IBC – FIRE SAFETY

Code Change No: **FS1-07/08**

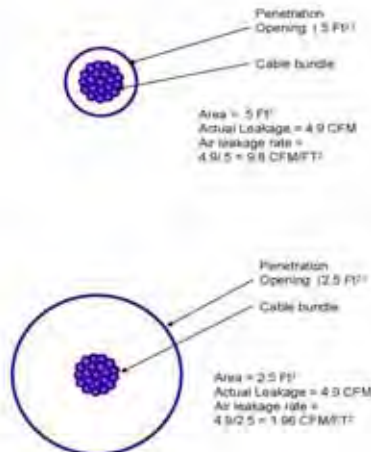
Section 712.5 as presently written in the 2006 IBC may actually have a negative impact on life safety by compromising the performance of the assembly by promoting the concept of creating larger openings or a series of smaller openings. The 5 cfm/sq ft value was prematurely added to the codes. It should be struck until such time that reporting methods improve or a better methodology for evaluating leakage through a smoke barrier can be developed.

I am not averse to leaving a reference to the air leakage tests of UL 1479 in the code for now provided that the value is eliminated. It plays up the importance of looking for tested systems, while not mandating a specific value that is arbitrary and subject to exploitation of present testing and reporting methods.

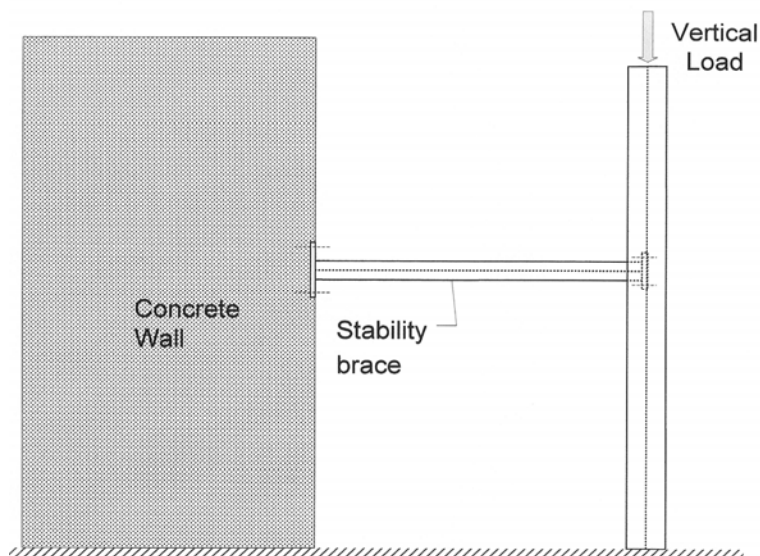
714.1.1 (Supp) Primary structural frame. The primary structural frame shall be is the columns and other structural members including the girders, beams, trusses and spandrels having direct connections to the columns and bracing members designed to carry gravity loads. Bracing members that are essential to the vertical stability of the primary structural frame under gravity loading shall be considered part of the primary structural frame whether or not the bracing member carries gravity loads.

Reason: The purpose of this code change is to clarify the code provisions regarding what portions of the structure should be considered “primary structural frame”, and therefore, require a fire-resistive rating.
